TECHNICAL SERVICE BULLETIN

TSB C-FN-0045

Subject: Additional Exhaust and Intake Termination Options for 90%+ AFUE Furnaces

Example 1: Intake and exhaust terminations through separate exterior walls

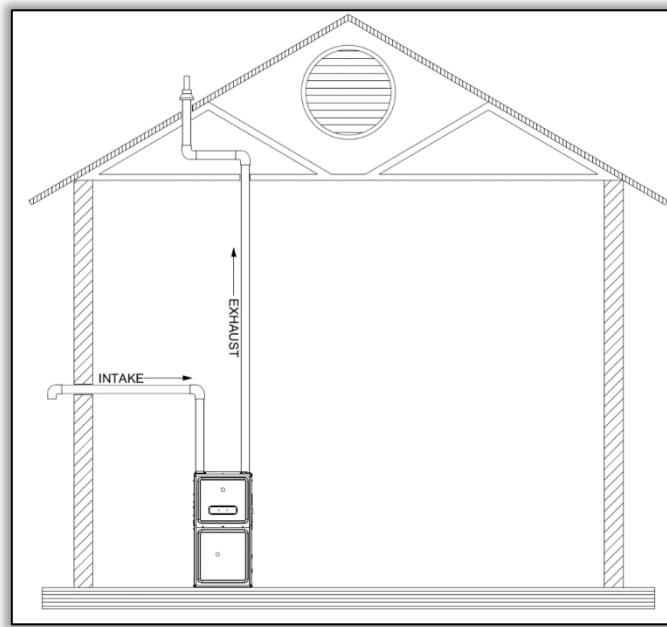
We are providing notification regarding flue vent and intake pipe termination options. Goodman, Daikin, and Amana® brand 90%+ AFUE residential furnaces are permitted to be installed with the exhaust and the intake vent terminations placed in two different pressure zones. The intake vent is allowed to be terminated on the side, exterior wall, while the exhaust vent may be terminated on another side, exterior wall, as shown in Example 1, or through the roof, as shown in Example 2. In addition, the combustion air intake can be terminated in a sufficiently ventilated attic while the flue vent terminates through the roof, as shown in Example 3 on the following page. Installer should take extra precaution from the effects of prevailing wind on the exhaust which could affect the venting of the flue.
